UNITED STATES PATENT AND TRADEMARK OFFICE

APPLICATION NO.	FILING DATE	FIRST NAMED INVENTOR	ATTORNEY DOCKET NO.	CONFIRMATION NO.
10/695,178	10/28/2003	J. Daniel Raulerson	MED0065	4287
33941	7590	04/27/2011	EXAMINER	
Fox Rothschild LLP Blue Bell 997 Lenox Drive Building 3 Lawrenceville, NJ 08648-2311			VU, QUYNH-NHU HOANG	
			ART UNIT	PAPER NUMBER
			3763	
			NOTIFICATION DATE	DELIVERY MODE
			04/27/2011	ELECTRONIC

Office Action Summary**Application No.**

DETAILED ACTION

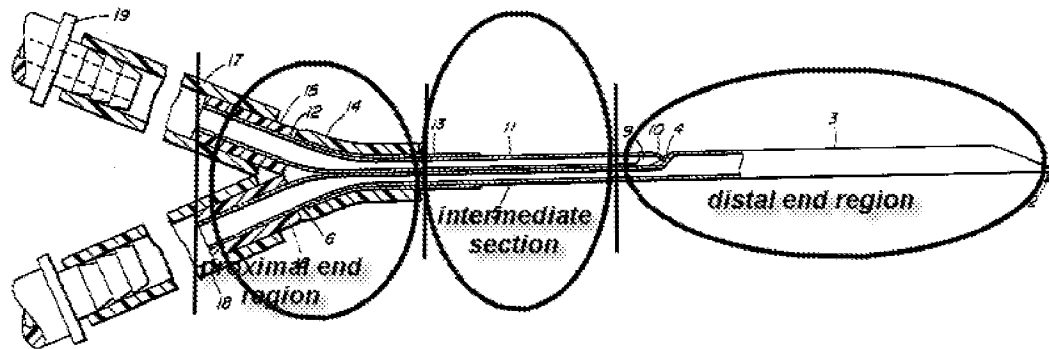
Regarding claim 34, Consalvo discloses a multiple catheter assembly shown in Fig. 7 comprising:

a first catheter 1 having a first distal end region 1 and a first proximal end region (at portion of element 16, see Fig. markup below) joined by a first intermediate section 11;

a second catheter 7 having a second distal end region 9 and a second proximal end region (at portion of element 15, see Fig. markup below) joined by a second intermediate section 5;

first and second extension tube assemblies 17 and 18 having first and second distal end portions respectively associated with the first and second proximal end regions of the first and second catheters;

a hub member 14 located around the first and second proximal end regions of the first and second catheters distally of the proximal ends thereof.

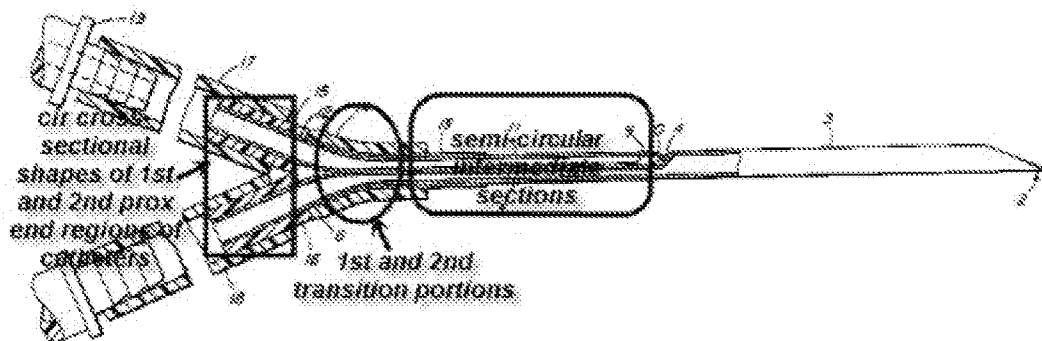
Consalvo further discloses that portions of the proximal end regions (at portions of element 15, 16) of the first and second catheters 1 and 7 extend through a hub member 14 and proximally beyond the proximal end of the hub member through respective exits and spaced apart from each other, to be connected to respective ones of the first 17 and second 18 extension tube assemblies, with other portions of the proximal end regions of the first and second catheters extend distally from the hub member separately from but adjacent to each other, see Fig. 1.

It has been held that the recitation “adapted to/capable of to be releasably attachable by a practitioner...” performing a function is not a positive limitation but only requires the ability to so perform. In re Hutchison, 69 USPQ 138. In this case, as seen in Fig. 1 or 7 of Consalvo, the hub member 14 of Consalvo is attachable but is not releasable. However, claim 34 only requires that the hub member is adapted to be releasably attachable by a practitioner. Therefore, the hub member of Consalvo can be used or modified with another releasably attachable hub member of either Cianci or Raulerson.
